Lower Thames Crossing

5.4.1.1 Draft Agreed Statement of Common Ground between (1) National Highways and (2) the Environment Agency (Clean version)

DATE: July 2023
DEADLINE:1

VERSION: 2.0

Plate 1: Proposed location of HRA and ecology mitigation

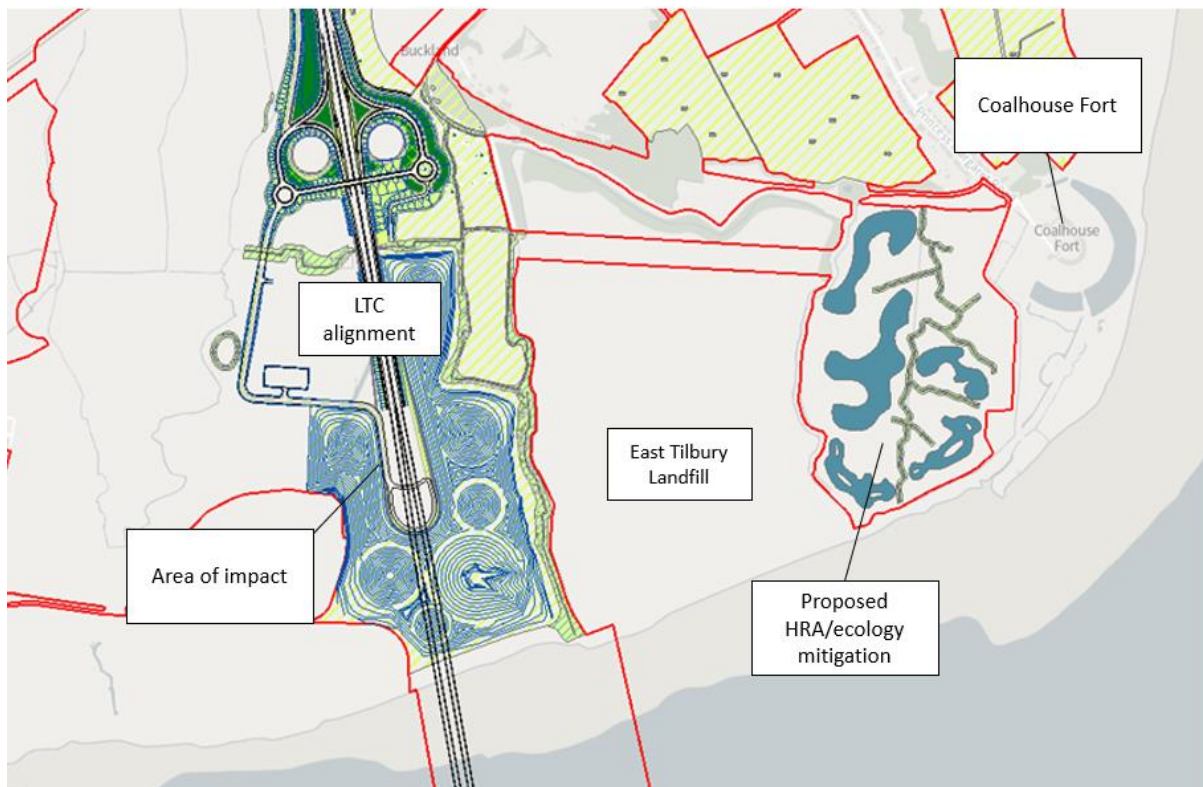
- The HRA and EIA require evidence that proposed mitigation is feasible. Natural England have advised that feasibility of the mitigation will need to be presented before they would be able to agree the sufficiency of the mitigation in the SoCG, which is a DCO acceptance risk and DCO consenting risk.

Plate 2: Proposed amendments to the DCO Order Limits to provide the 50mx20-35m working space for the construction of the sluice structure. Approximate amendments to Order Limits to incorporate flood defence also highlighted.

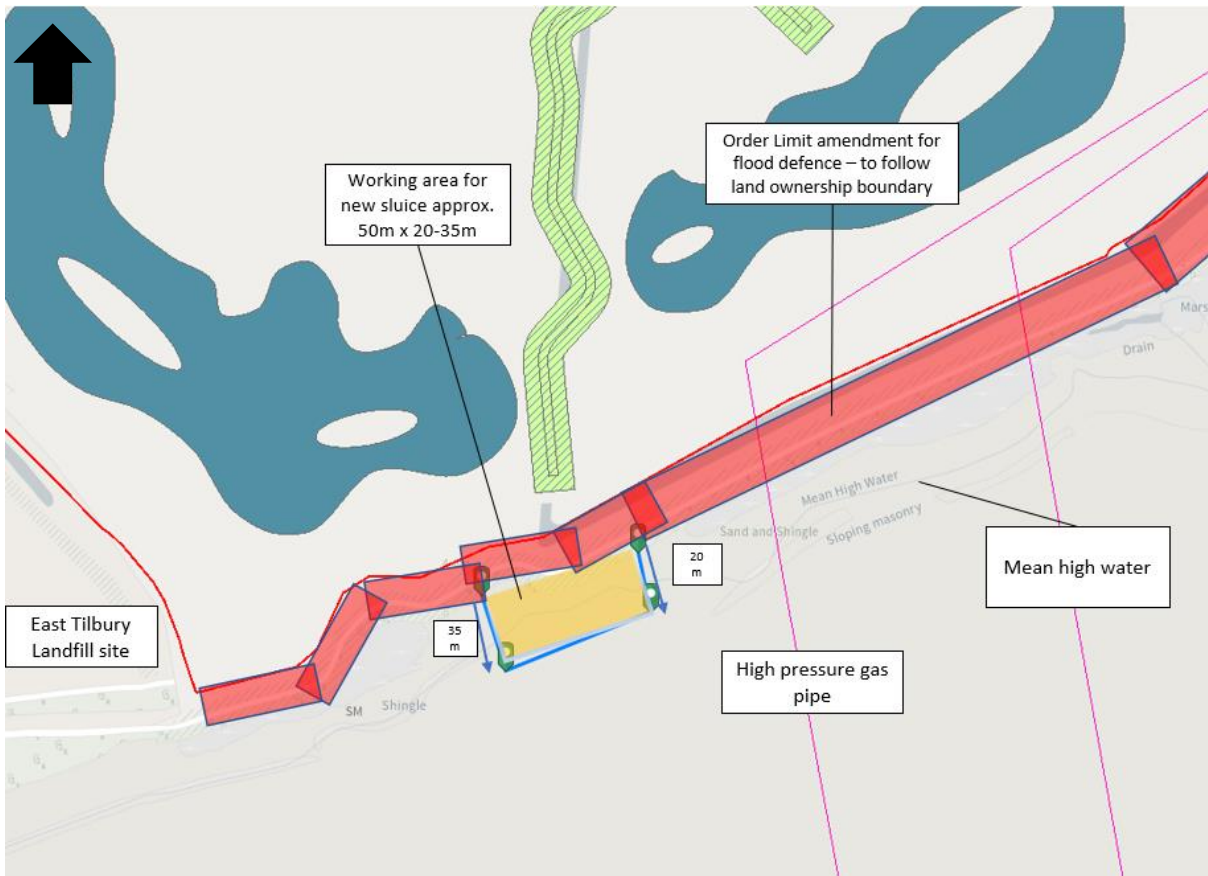
It was proposed to amend the Order Limits to incorporate the existing flood defence that is currently owned by the landowner, Mr Mott. This change was proposed irrespective of the requirement of a structure and is shown as the red area in Plate 2. Given the new structure would be limited to the footprint of the flood defence, this change would also incorporate the new structure.

Figure 1: Impact of increased defence levels on breach start and end times at Mardyke Sluice breach (based on future level for Option 1.4 in 2127)

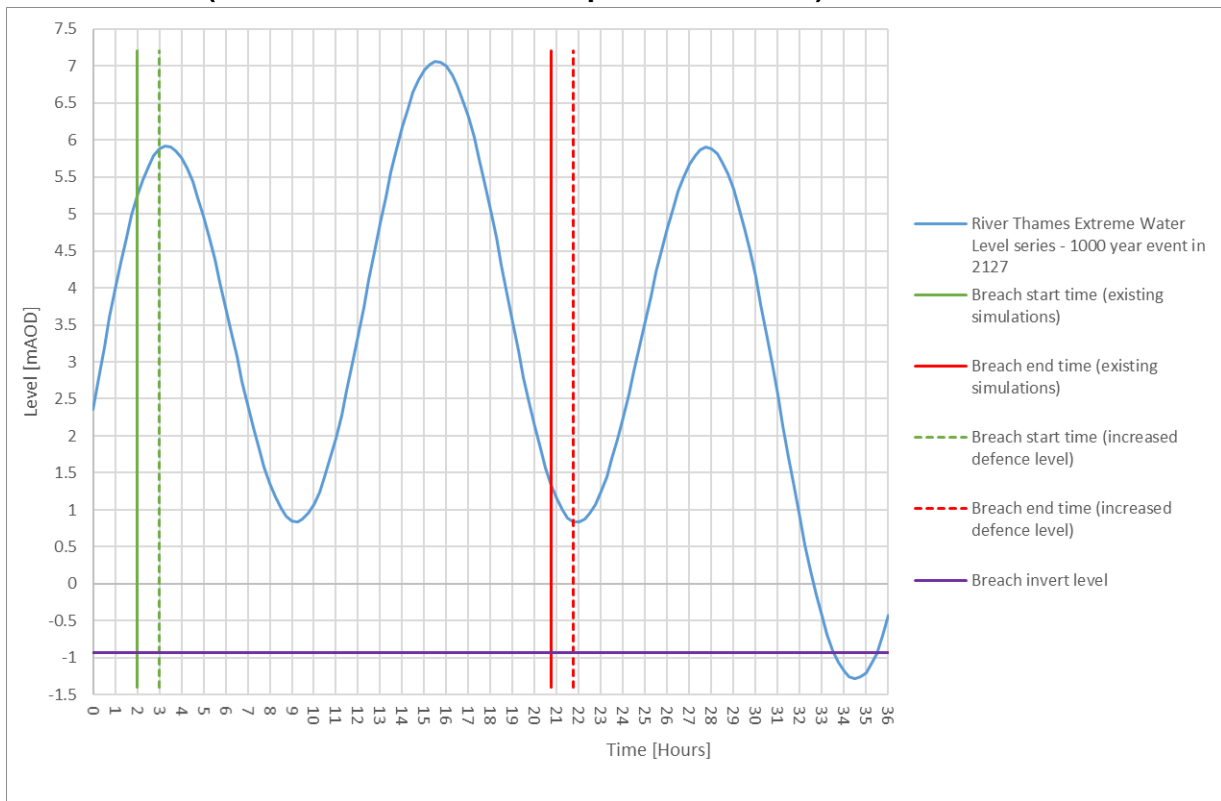
- 2.2.4 Figures 1 to 3 show the influence of increasing flood defence levels on breach start and end times for the LTC FRA breach simulations. The change in breach start and end times is shown for the highest required future defence levels (i.e. the future defence levels that are most different to those assumed in the LTC FRA breach simulations, highlighted in orange in Table 2).

2.2.5 Figures 1 to 3 show that for all LTC FRA breach locations, applying higher flood defence levels results in a delay in the start and end times of simulated breaches. An inspection of Figures 1 to 3 indicates that the reduction in initial breach flows resulting from increased defence levels (due to a delayed start) would exceed the gain in breach flows at the end of the simulated breach event, as River Thames flood levels are higher at the start of simulated breach events than at the end of the events (and for TIL005 there would be no gain in breach flows at the end of the simulated breach event, as River Thames levels would be below the TIL005 breach invert level at the end of the simulated beach). There would therefore be an overall reduction in simulated breach flood volume as a result of increasing flood defence levels.

Figure 2: Impact of increased defence levels on breach start and end times at TIL005 breach (based on future level for Option 3.2 in 2127)

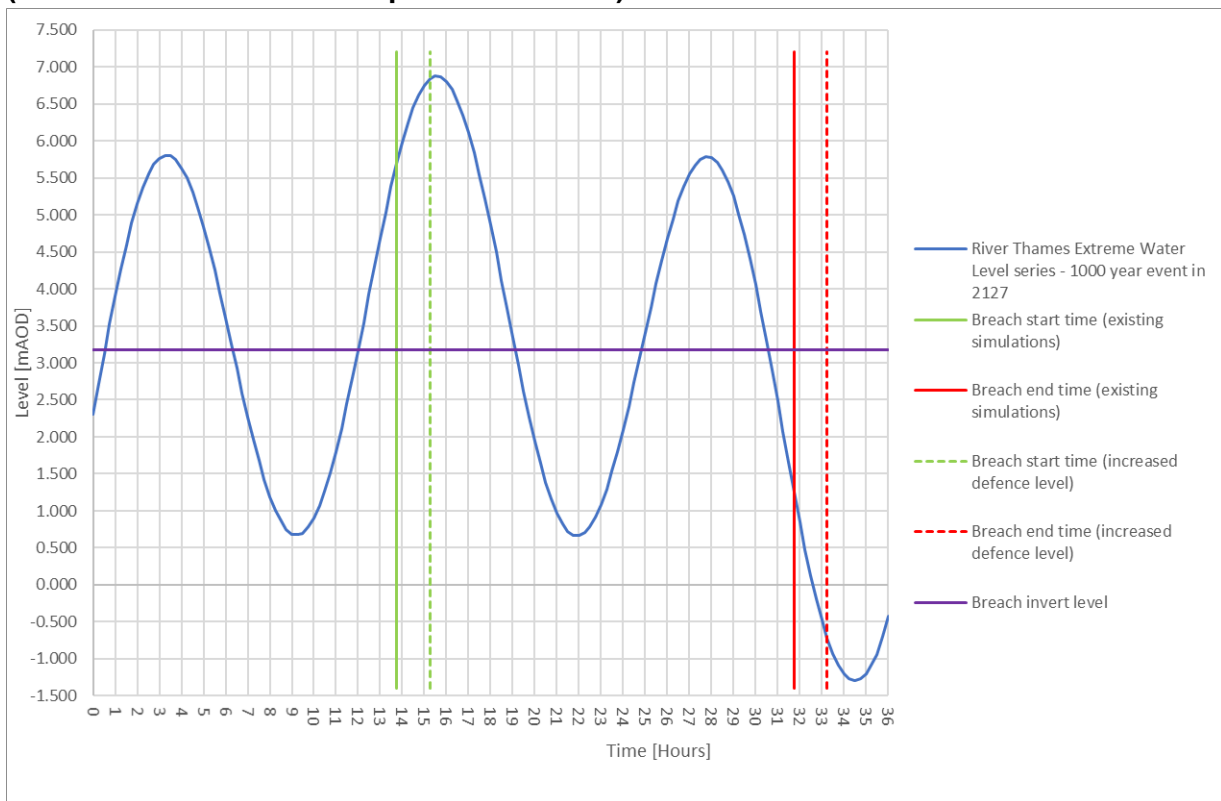
2.2.6 The LTC FRA breach simulation results show the nearest parts of the LTC Project within TIL005 and TIL006 breach event flood extents are approximately 2km and 0.8km respectively from the breach locations, with simulated peak velocities significantly lower than at the breach locations. The influence of an increase in flood defence levels on breach impacts at the LTC Project would therefore be dominated by total breach volume (i.e. breach flood extent and level).
